ADDENDUM # 3

To: File 1903-910-65-4901
IFB for: Castle Point Exterior Renovations and Site Improvements

EXTERIOR IMPROVEMENTS TO CASTLE POINT APARTMENTS

SHEET: TR1
TREE REMOVAL PLAN

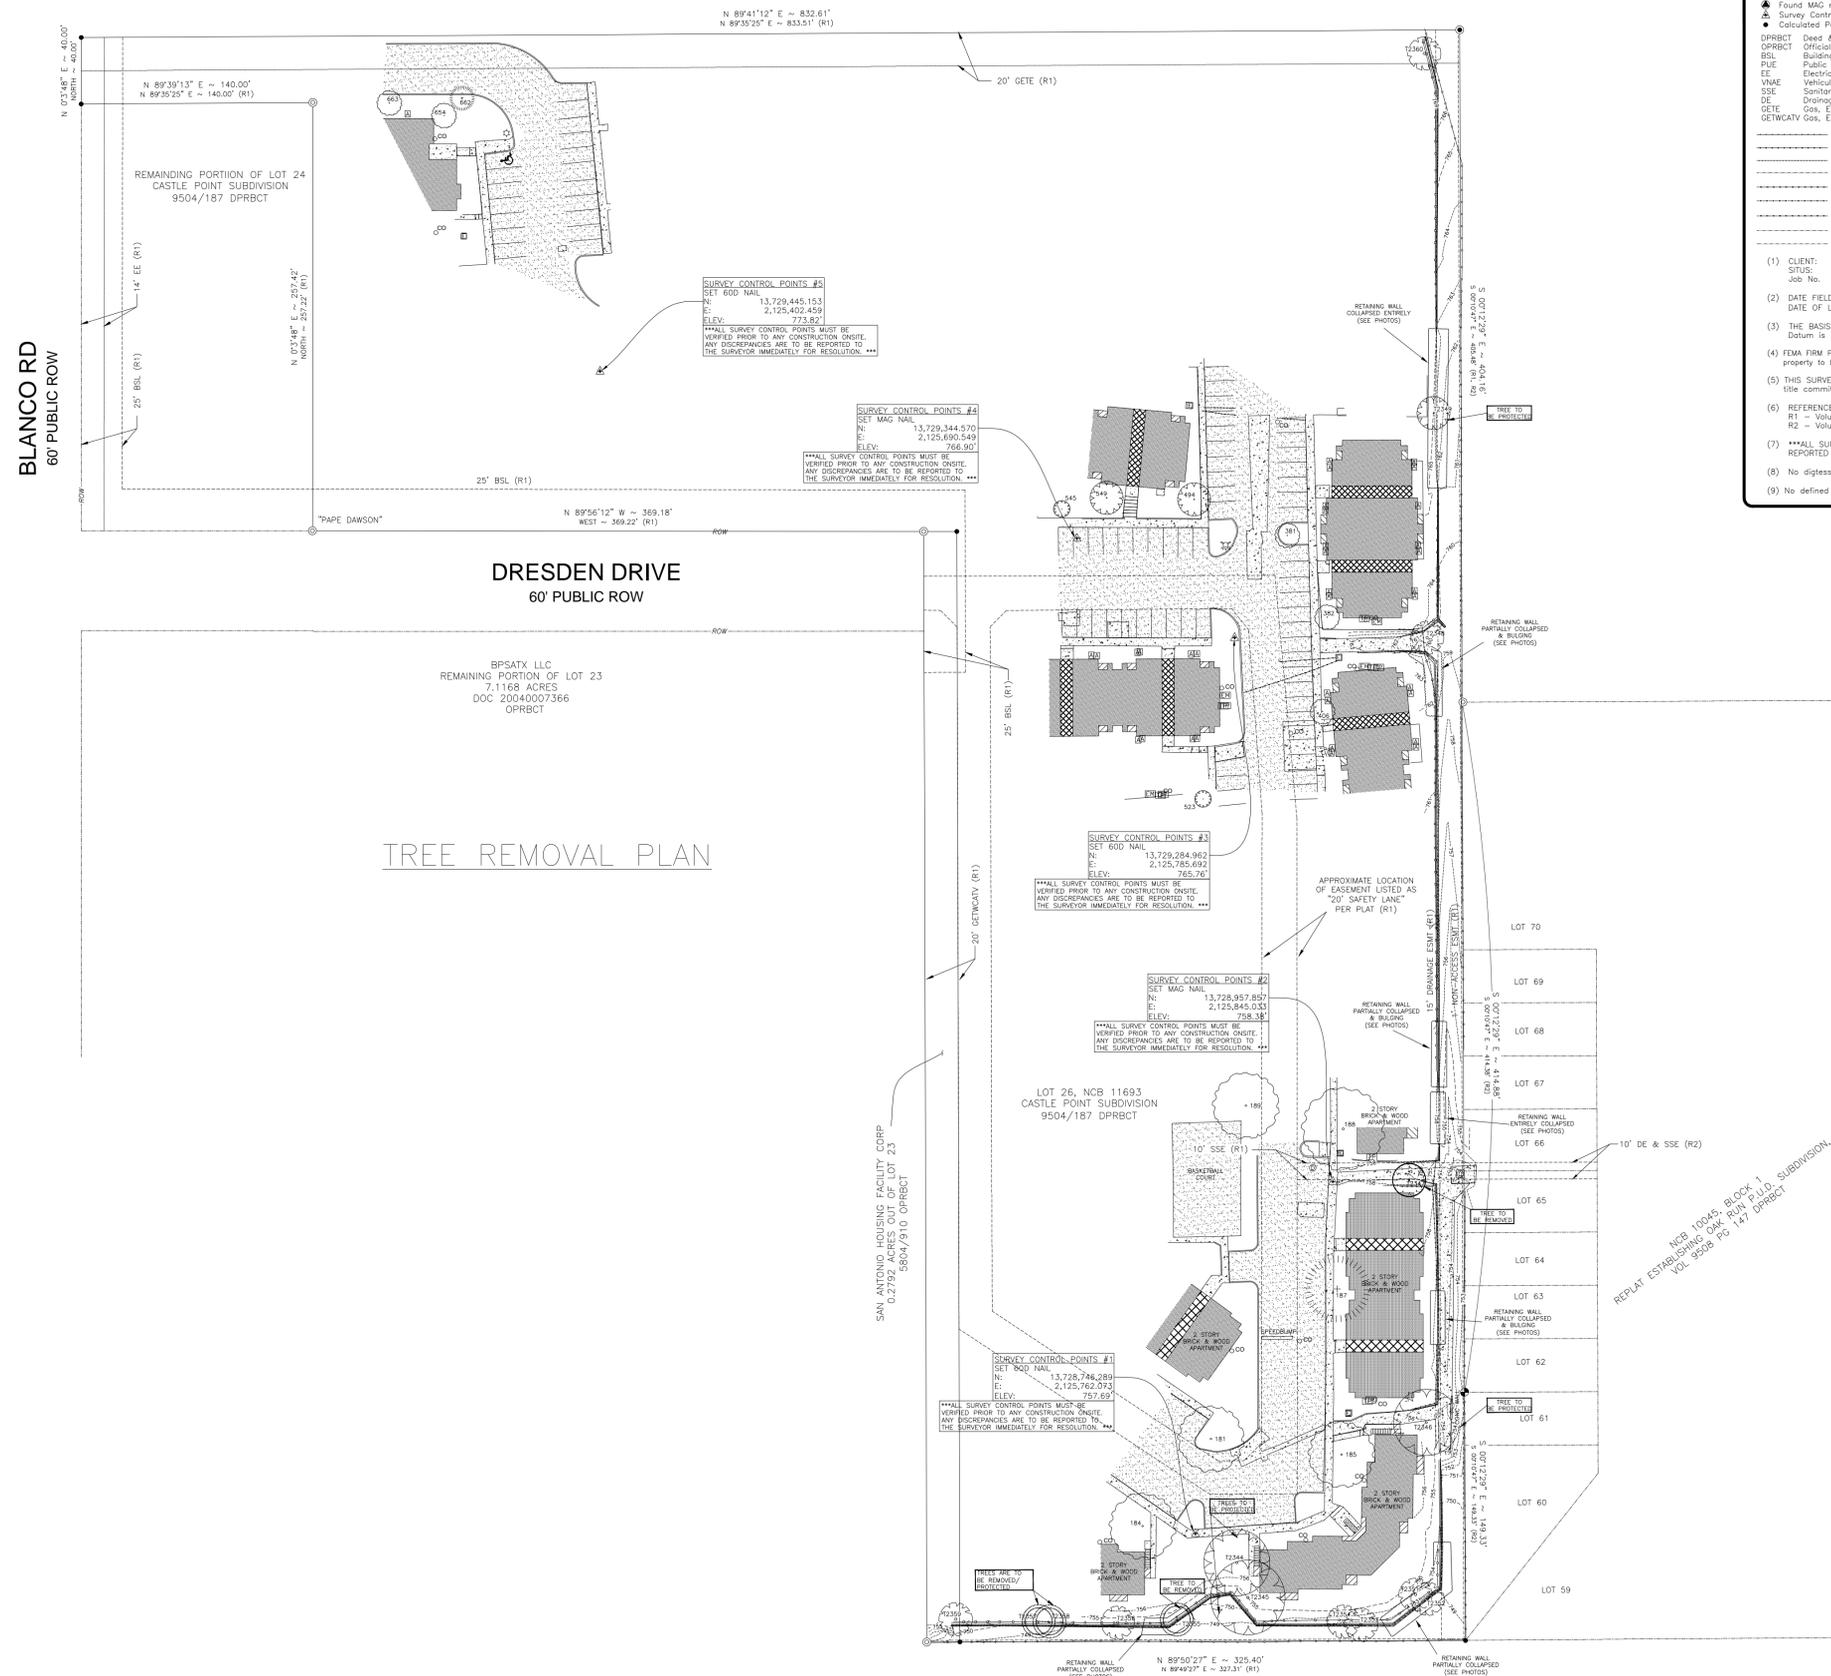
- Question 12:** Some trees are in the way of the retaining walls. Can these be removed without replacing these trees?
- Answer 12:** Please see tree survey. (ATTACHED) The trees to be protected/remain and to be removed are noted. Contractor must follow the items described on the documents.

Question 32: In regards to the retaining wall. There are over 20 trees that are just in the retaining wall excavation area per spec C9.2, are we to factor there removal into the base bid or will the awarded contractor address this as a change order?

Answer 32: Please see tree survey. The trees to be protected/remain and to be removed are noted. Contractor must follow the items described on the documents.

NON-SIGNIFICANT TREE TO BE REMOVED LIST	
T=TAGGED	
T2348	18" CHINA BERRY - TO BE REMOVED
T2351	12" CHINA BERRY - TO BE REMOVED
T2352	11" CHINA BERRY - TO BE REMOVED
T2353	10" CHINA BERRY - TO BE REMOVED
T2354	11" CHINA BERRY - TO BE REMOVED
T2355	12" CHINA BERRY - TO BE REMOVED
T2359	11" CHINA BERRY - TO BE REMOVED

SIGNIFICANT TREE TO BE REMOVED LIST	
T=TAGGED	
T2347	20" MEXICAN SYCAMORE - TO BE REMOVED
T2355	12" BOIS D' ARC - TO BE REMOVED
T2357	8" BOIS D' ARC - POSSIBLY AFFECTED BY CONSTRUCTION - REMOVE AS NECESSARY
T2358	6" BOIS D' ARC - POSSIBLY AFFECTED BY CONSTRUCTION - REMOVE AS NECESSARY

TREE TO BE PROTECTED	
T=TAGGED	
T2344	16" MEXICAN SYCAMORE - TREE IS TO BE PROTECTED DURING CONSTRUCTION
T2345	22" MEXICAN SYCAMORE - TREE IS TO BE PROTECTED DURING CONSTRUCTION
T2346	17" MEXICAN SYCAMORE - TREE IS TO BE PROTECTED DURING CONSTRUCTION
T2349	23" MEXICAN SYCAMORE - TREE IS TO BE PROTECTED DURING CONSTRUCTION
T2357	8" BOIS D' ARC - POSSIBLY AFFECTED BY CONSTRUCTION - PROTECT/ REMOVE AS NECESSARY
T2358	6" BOIS D' ARC - POSSIBLY AFFECTED BY CONSTRUCTION - PROTECT/ REMOVE AS NECESSARY

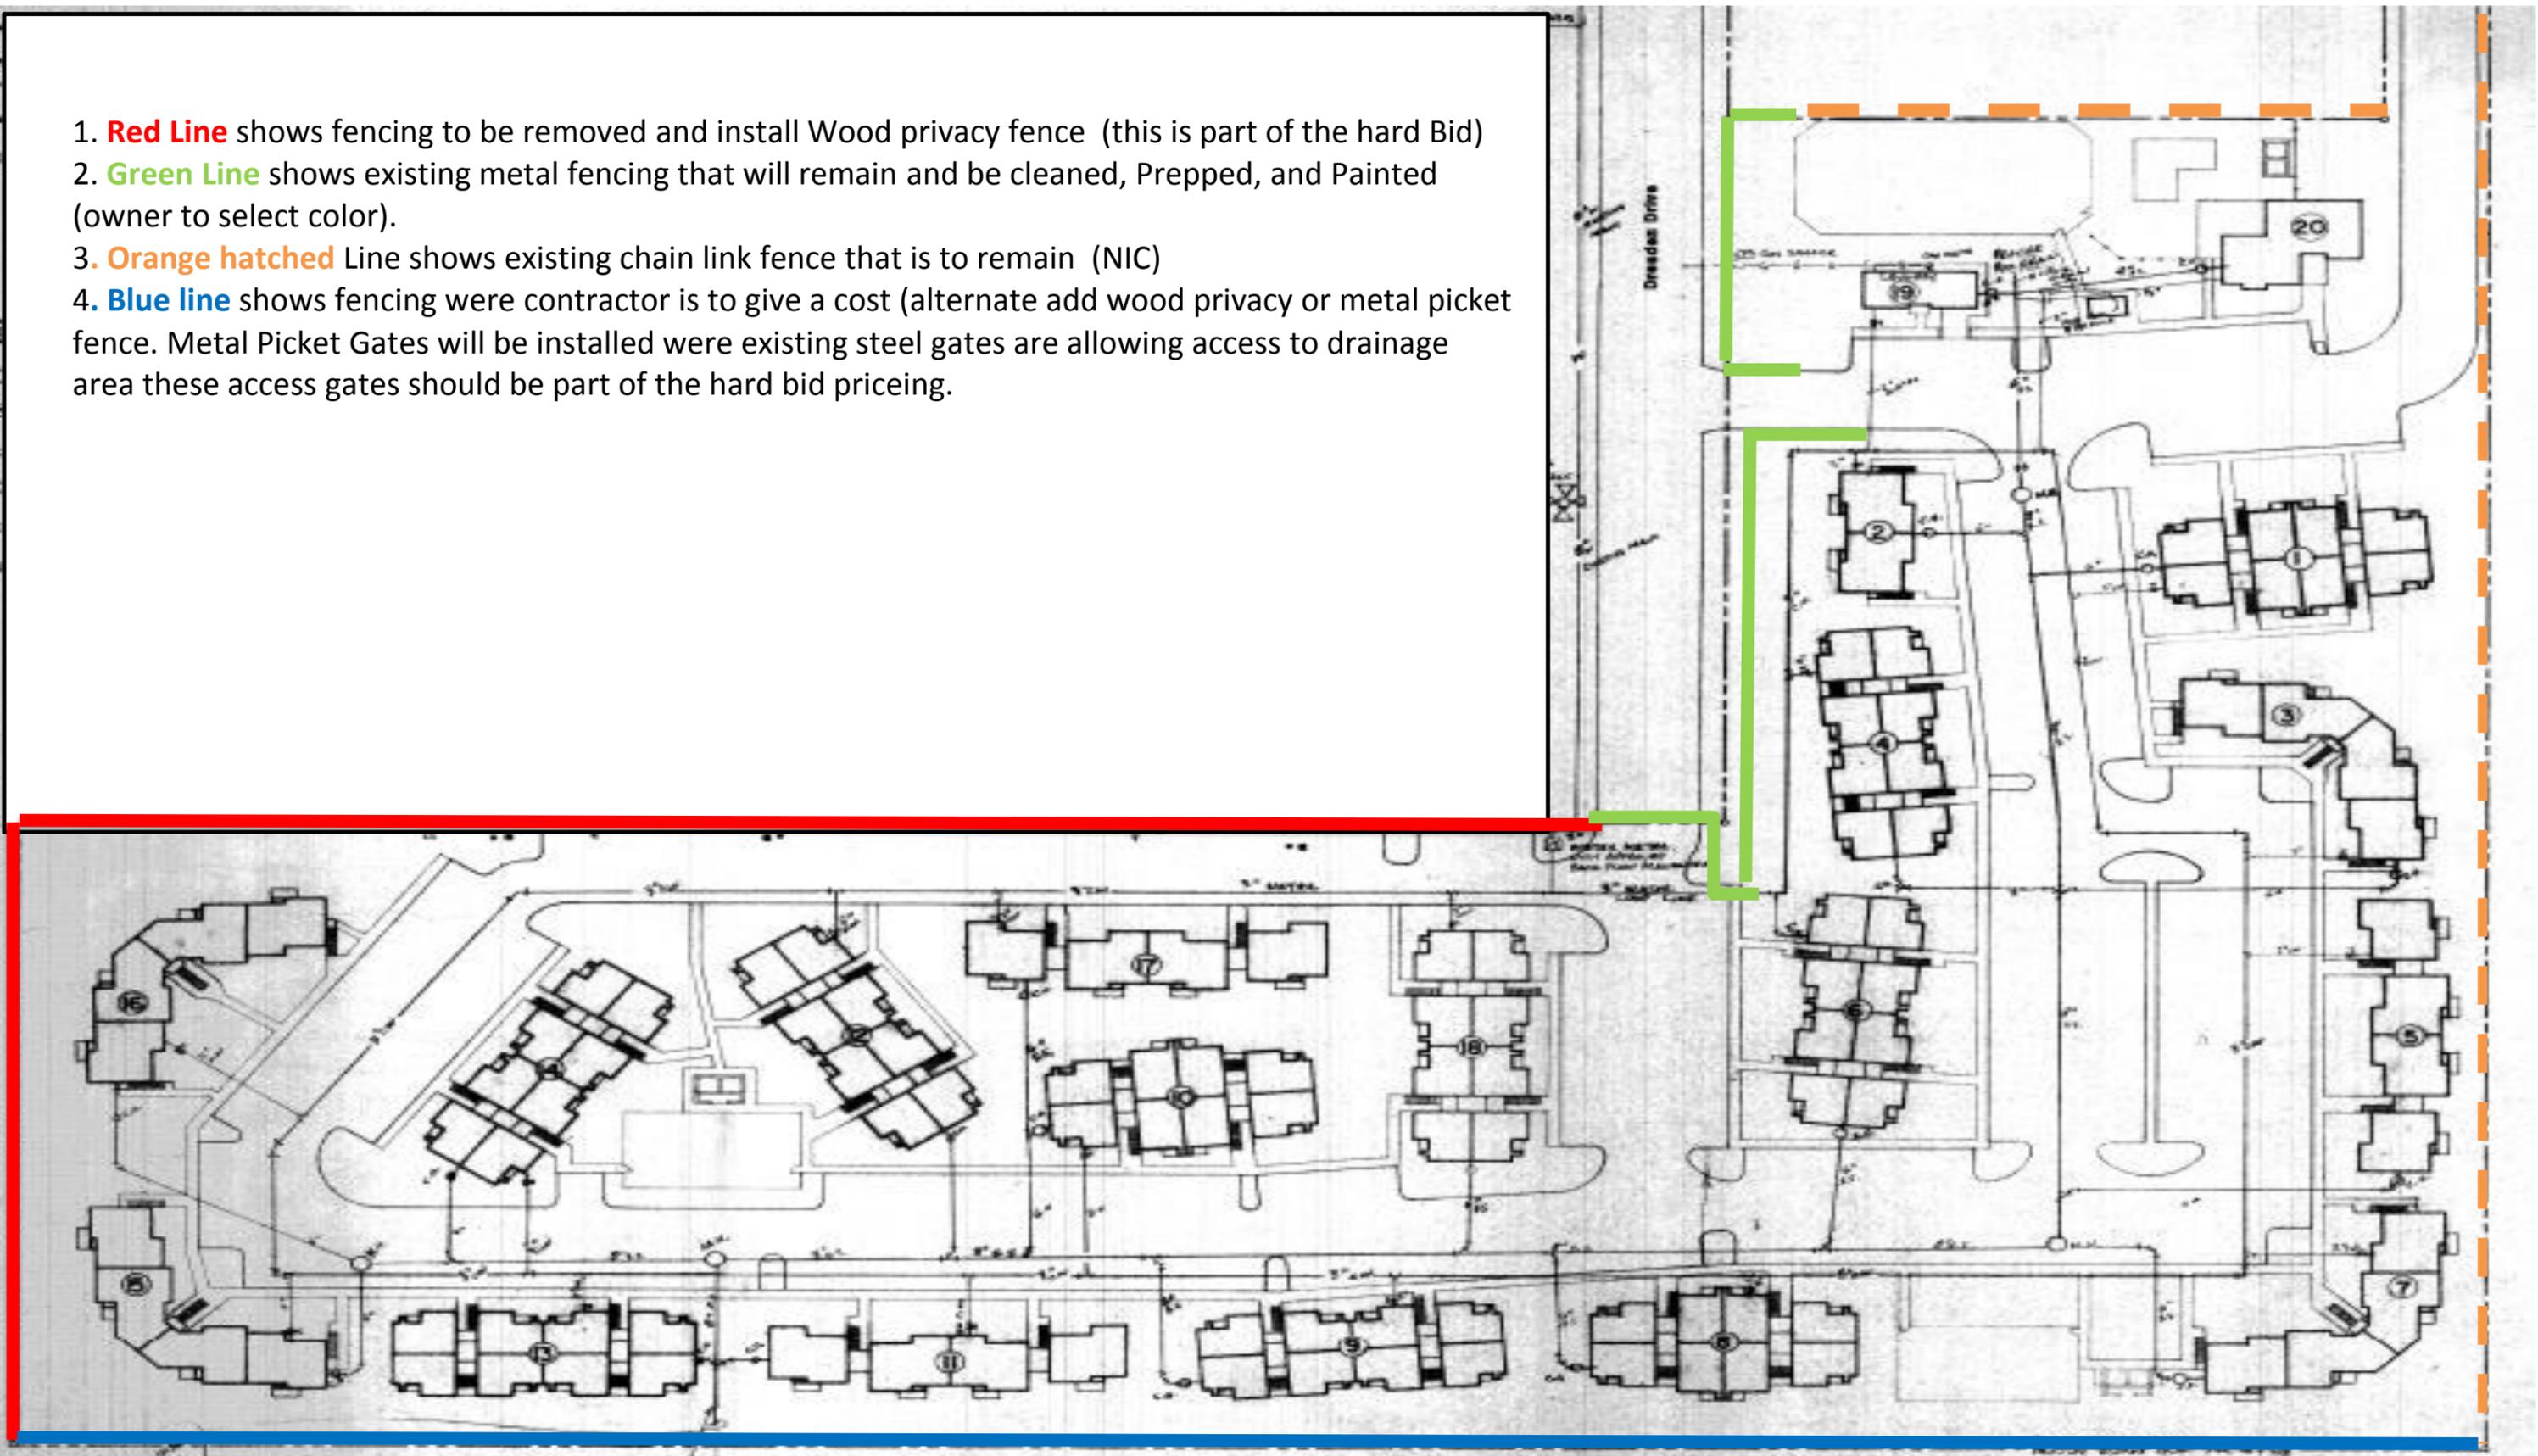
Tree Permit application is provided with this document/email, the permit application is for the removal of four trees located along the south and southeast property line. According to the tree survey, none of the trees that are proposed to be removed are heritage trees. According to the limited tree survey we had performed on the site, we still were able to obtain an 81% tree preservation percentage; please see: the Tree inventory table, survey, aerial image, and tree removal plan for further information.
